Regulation No. 65 (Special warning lamps)

Proposal for amendments to Regulation No. 65

Submitted by the expert from the Society of Automotive Engineers*

Annex 5, paragraph 6.1.

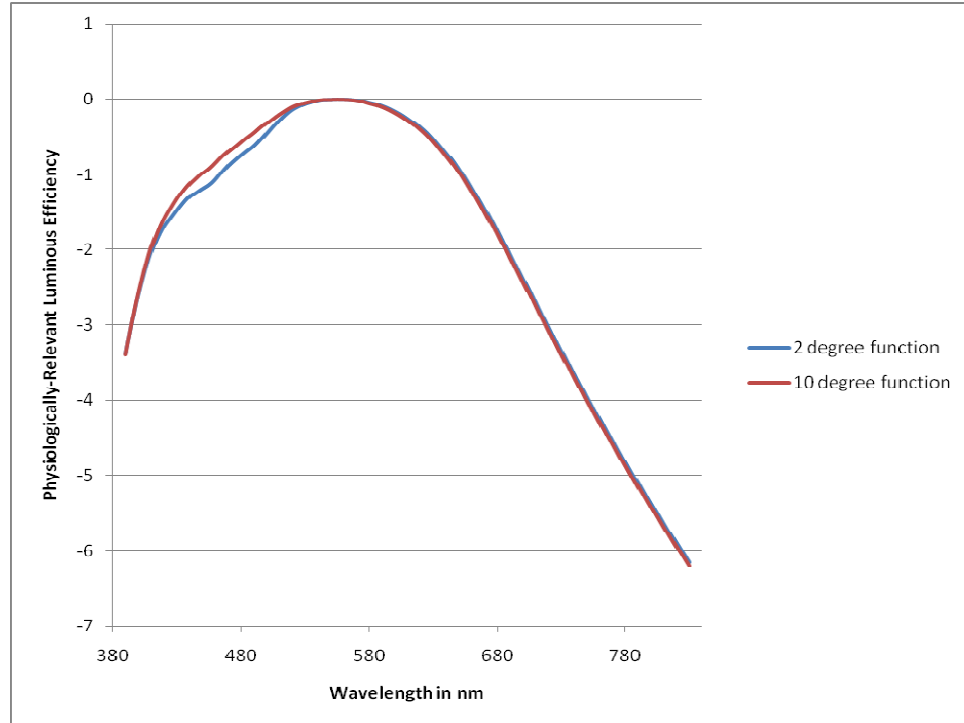
"6.1. **The measurement of the flash timing characteristics of a special warning lamp where the light output rotationally changes along the surface of such lamp, shall be made with an adequate distance between the sensor and the lamp, such that the sensor is able to assimilate the light from the total surface of the lamp facing the sensor. The distance of the sensor from the special warning lamp should be adjusted such that the aperture**

through which the sensor is receiving the light, allows full view of the special warning lamp for the sensor."

25. This paragraph has been added as a guideline to bring clarity for measurement of Flash timing characteristics, since there are no established rules in this regard.
